# SERVICE BULLETIN

ENGINE - REMOVE MATERIAL FROM THE LEADING EDGE OF STAGE 2.0 COMPRESSOR BLADES TO IMPROVE CLEARANCE - CATEGORY CODE 6 - MOD.ENG-72-0001

V2500-ENG-72-0001

Outline of rework  
Fig.1

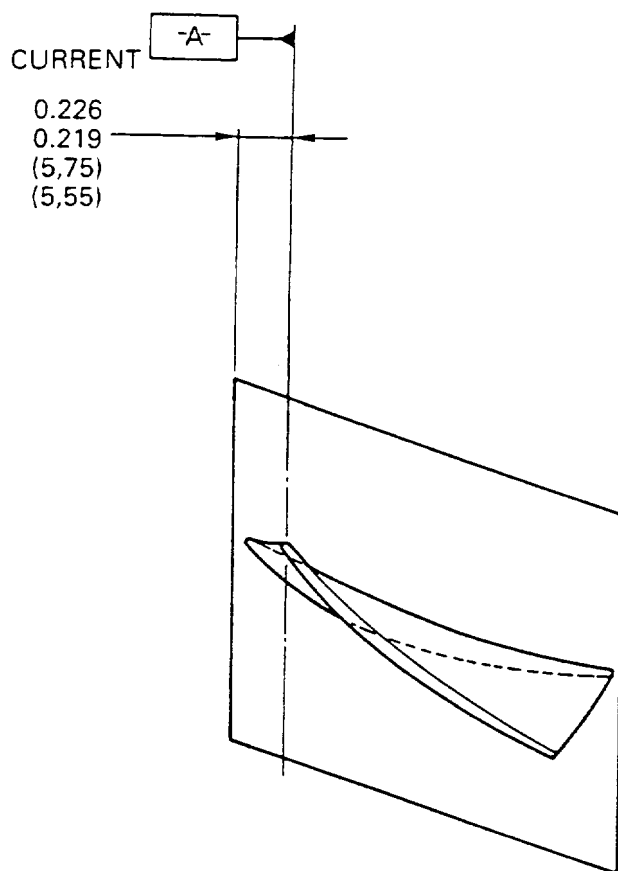
- (1) Rework 5R7105, Blade, STG 2.0 LPC (See Reference (1), 72-32-82, Fig/Item No.01-250) and reidentify as follows.

Procedure	Supplementary Information
(a) Set-up and machine the platform of Blade	Refer to Figure 1, 2 and 3
(b) Finish the machined area	Refer to Figure 3 and 4. Break sharp edges 0.004 to 0.011in. (0,1 to 0,3 mm). Tool: RB010, Grinder, hand held pneumatic or equivalent

Fig.4

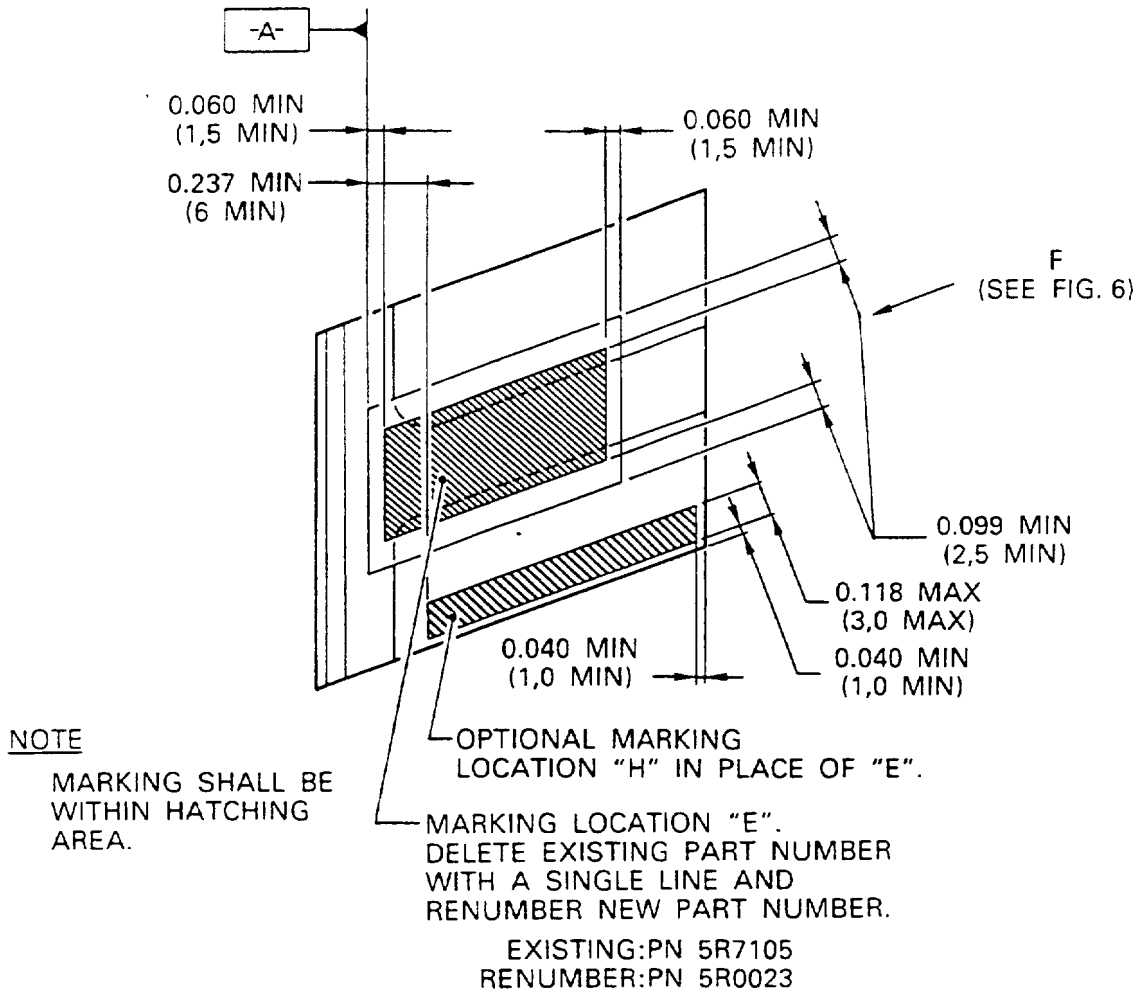
NOTE: Silicone carbide type wheels, stone and abrasive papers are to be used.

Aluminum oxide type papers must not be used.

Marking location  
Fig.5

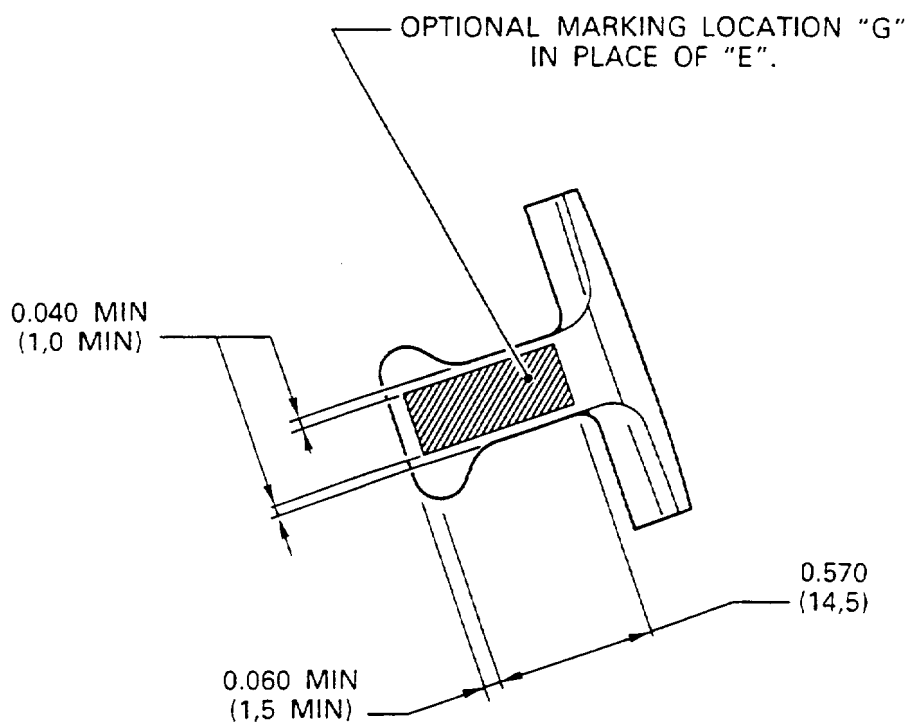
(c) Delete existing Part Number with a single line and renumber New Part Number	Refer to Figure 5 and 6. Mark by vibro-peen, Ident No.AD005 or equivalent
	Old Part Number      New Part Number
	5R7105                      5R0023

- NOTE: 1. Marking locations 'G' and 'H' are permissible to mark if location 'E' does not have a sufficient area for marking.
2. Refer to Standard Practices/Processes Manual TASK 70-09-00-400-501.
3. All raised metal which exceeds 0.0009in. (0,025 mm) must be removed.
